Our Ref: IDA23/82

**Proposal: IDA referral for replacement jetty and seawall works**

**Property: 15 The Chase, Lovett Bay NSW 2105 (Lot 3 & 4 DP 22826) – Pittwater**

2081 - DA 02

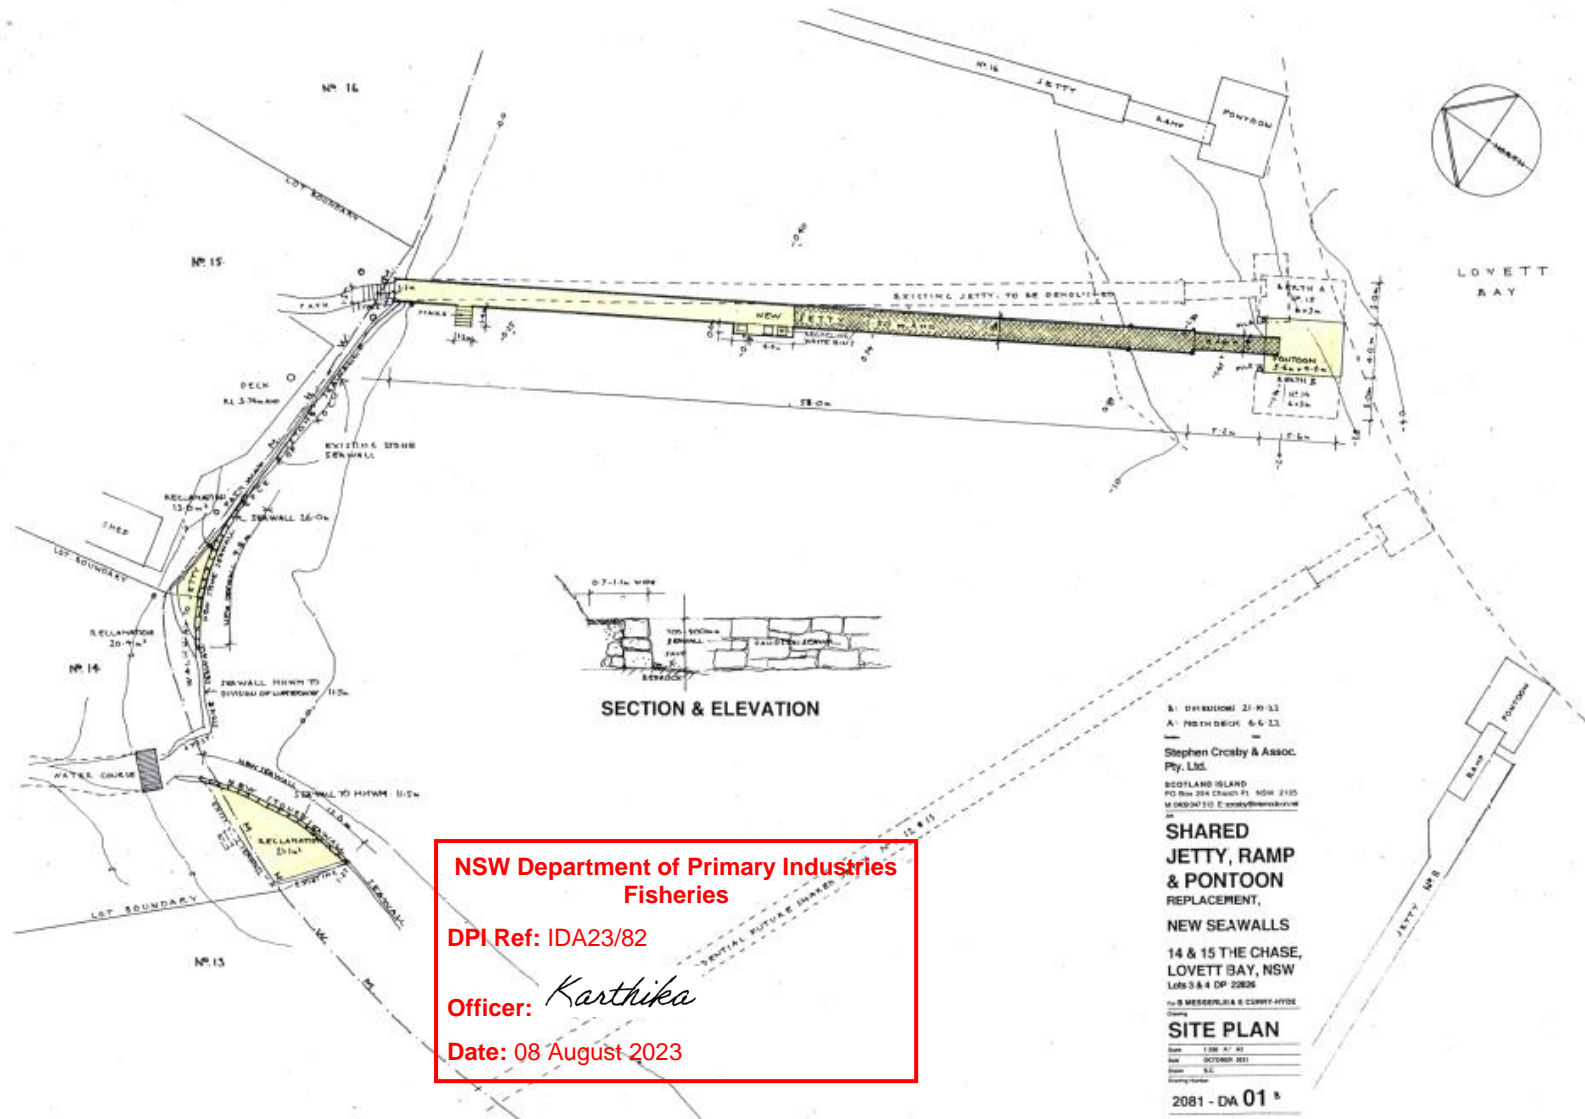
3. A minimum of 900 mm is to be maintained between the underside of the pontoon/sea stairs and the substrate at all times and
4. DPI fisheries recommend that the seawall is constructed in accordance with the "[Environmentally Friendly Seawalls: A Guide to Improving the Environmental Value of Seawalls and Seawall-Lined Foreshores in Estuaries](#)". In order to enhance the habitats for biodiversity, it is suggested to avoid cementing between the sandstone seawall blocks.
